Agenda
Village of Arlington Heights
Design Commission
Community Room, 3rd Floor
Arlington Heights Village Hall, 33 S. Arlington Heights Rd.
July 11, 2023
6:30 PM

MINUTES OF THE VILLAGE OF ARLINGTON HEIGHTS DESIGN COMMISSION

Item: DC#23-024 - Portillo's - 806 W. Dundee Rd. / Sign Variation

STAFF DESIGN COMMISSION REPORT

Drive-Thru Elevation - Before

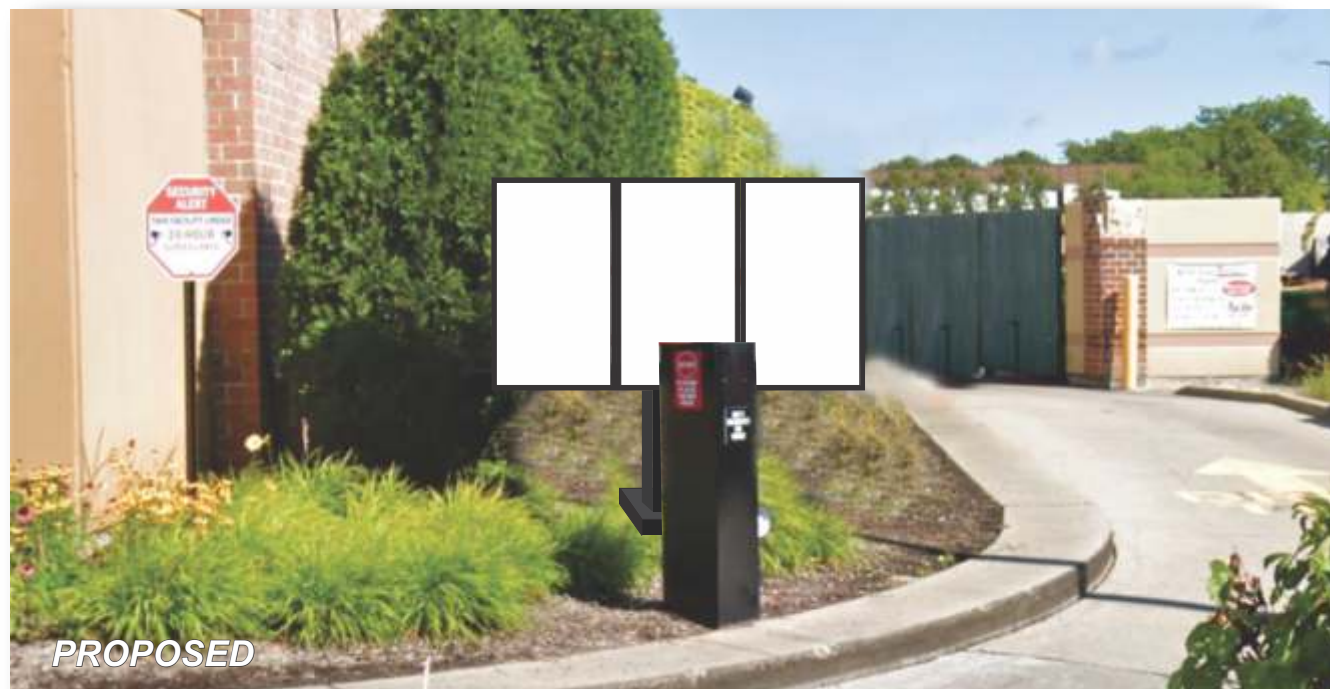
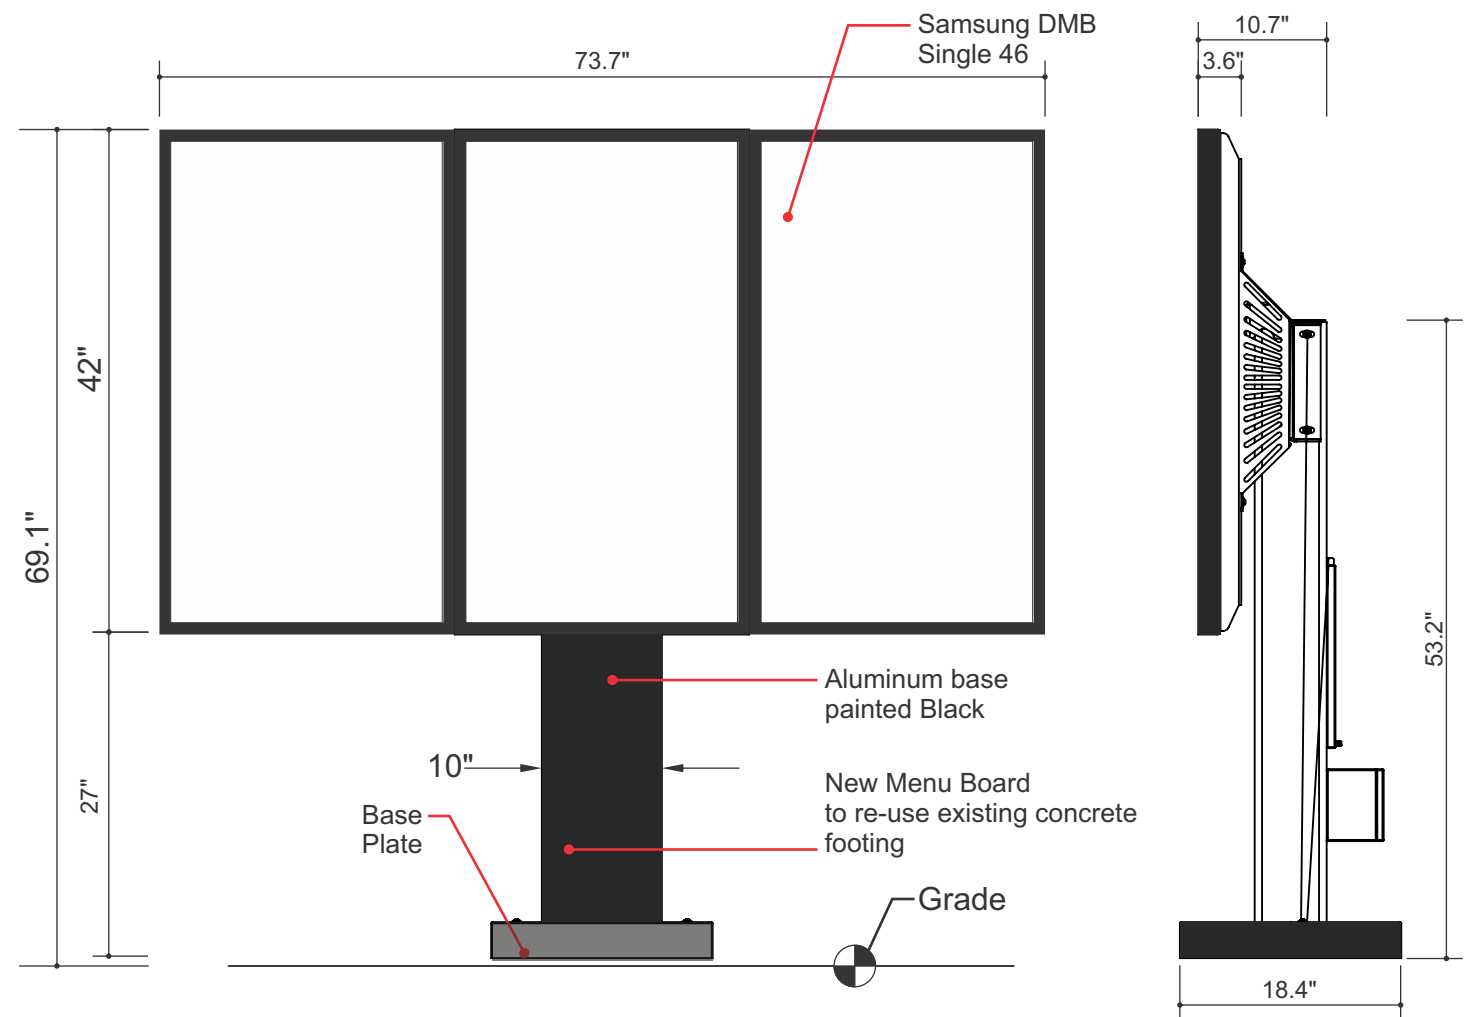
Overall, Staff does not object to the use of fully electronic menu boards since they allow for easier menu updates and they are generally smaller than conventional menu boards. Similar fully electronic menu boards have been previously approved in Arlington Heights for McDonald's and Burger King. However, the McDonald's and Burger King electronic menu boards are located at the rear of the building as required by code. Since Portillo's electronic menu board signs will be in front of their building and visible from Dundee Road, it is important that the operation of the signs be used for drive-through menu displays only, and not used to display other advertisements, such as video commercials, when the drive-through is not in use. Additionally, Staff recommends that new/additional landscaping be provided to improve screening of the electronic menu boards from the street.

1. Provide new/additional landscaping to be approved prior to issuance of a permit to improve screening of the electronic menu boards from the street.
2. The electronic menu boards will display drive-through menu signage only, and will not be used to display any other advertisements.
